CLAREMONT BUSINESS PARK 2 FILING NO. 2

CONSTRUCTION PLANS

JULY 2023

LOT 2 - SAND FILTER POND 3
SPILLWAY PLAN
SCALE 1"=10'

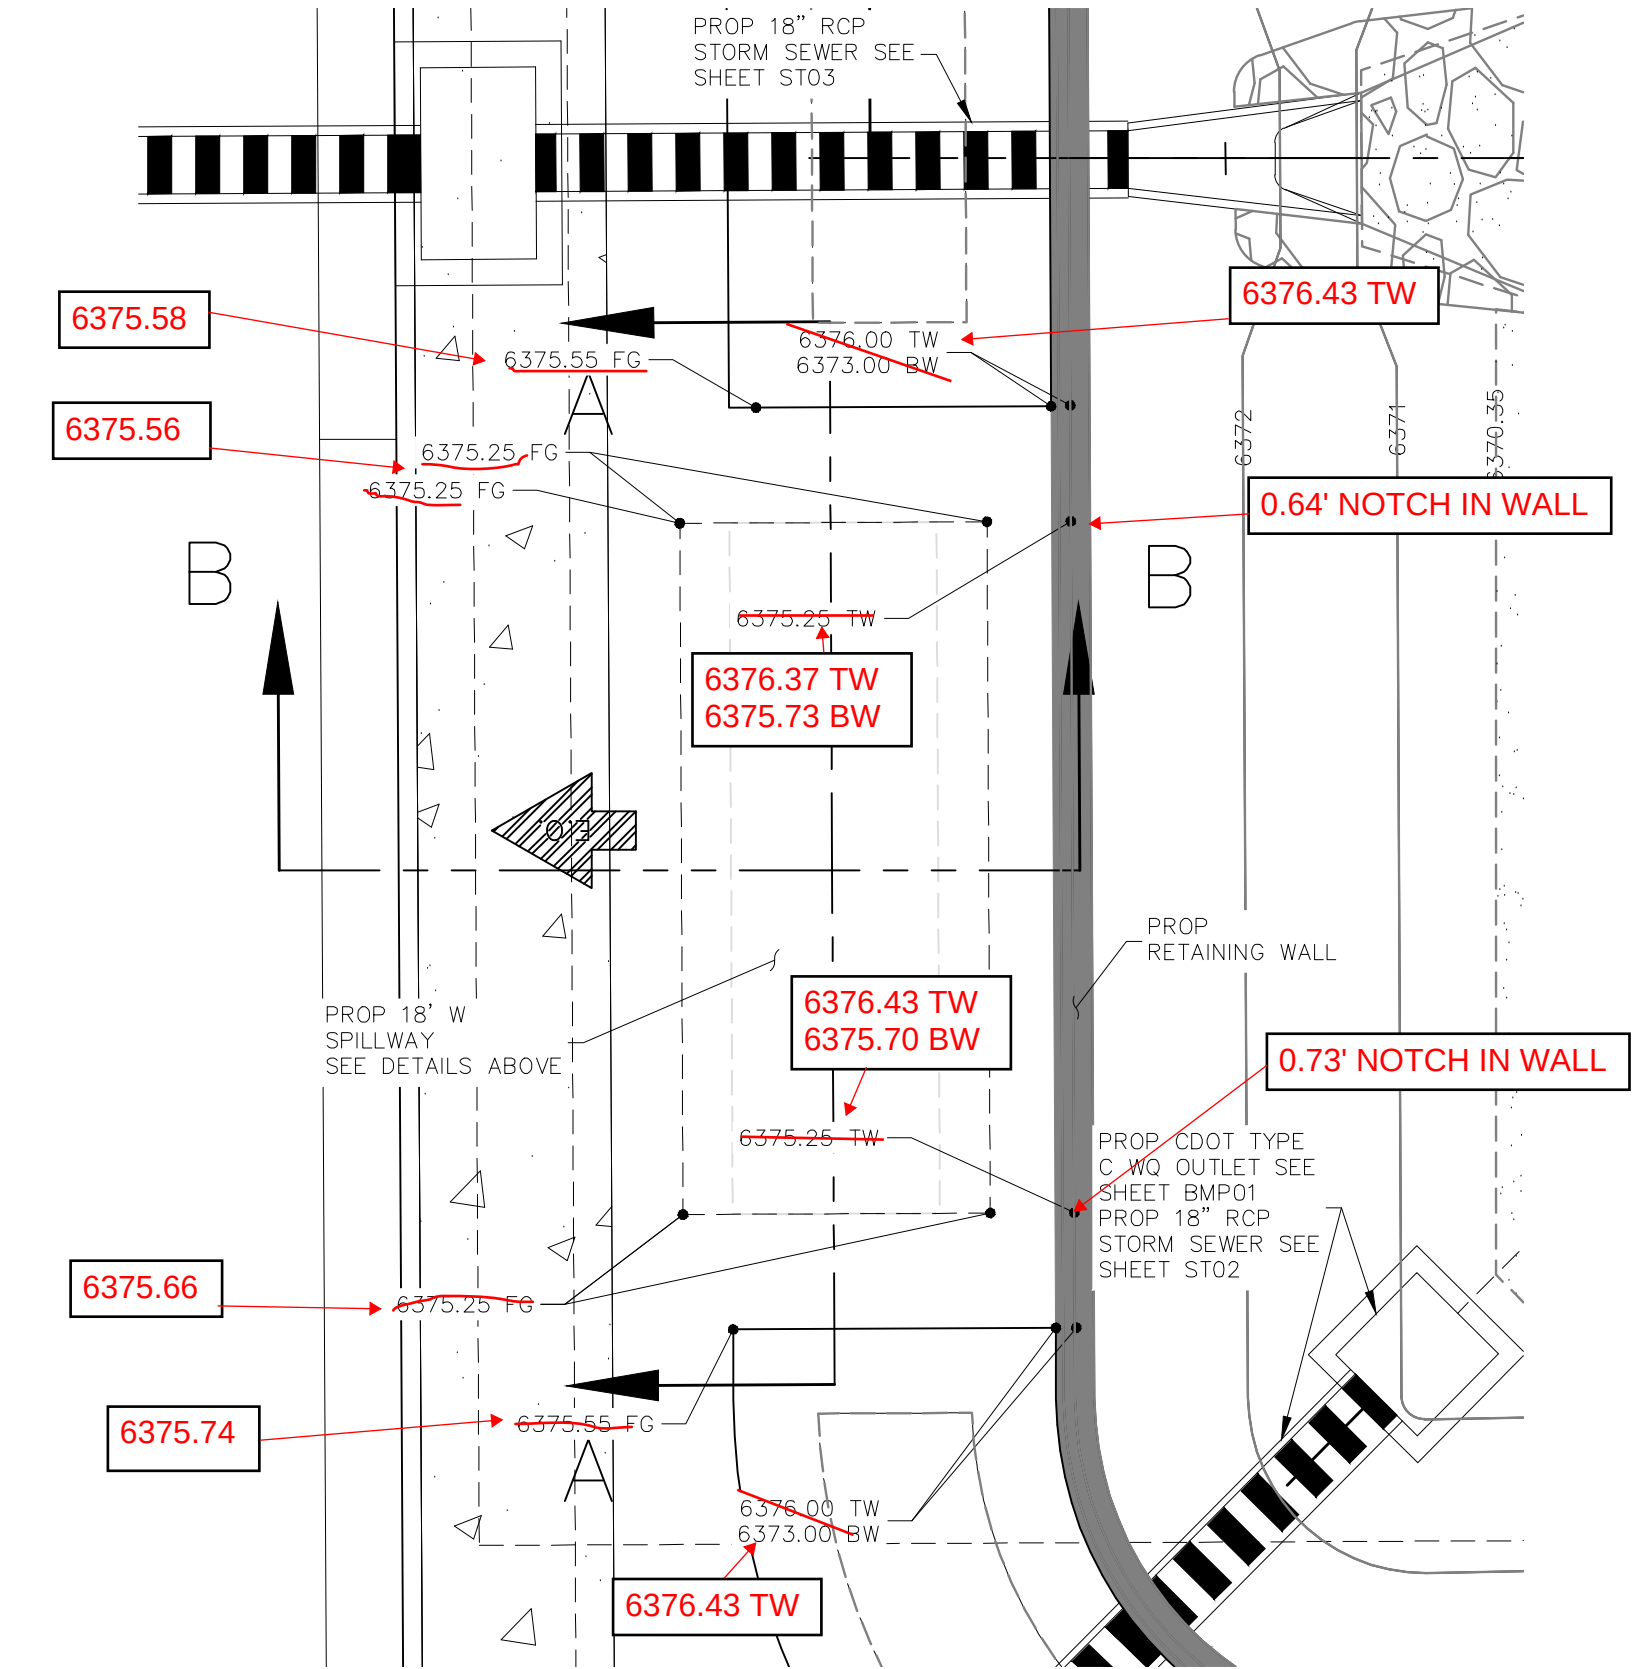
My V2 comment:
The side walls of the spillway are vertical, not 4:1. Please reflect this on this detail (already addressed on calcs, so those are good).
V3 update:
I see in your Comment Response doc that Section A-A is not at the wall. But that was not the crux of my comment. The point was that the controlling portion of the spillway is the notched wall upstream of Section A-A. So that's what should be reflected in the calcs (you have since incorrectly changed the calcs to reflect the 4:1 side slopes at Section A-A) and shown in an as-built detail. Obviously you are welcome to keep this Section A-A as-built detail to show the conveyance channel just downstream of the actual spillway if you want, but one is needed for the actual spillway crest.
See my V2 comments on this detail.
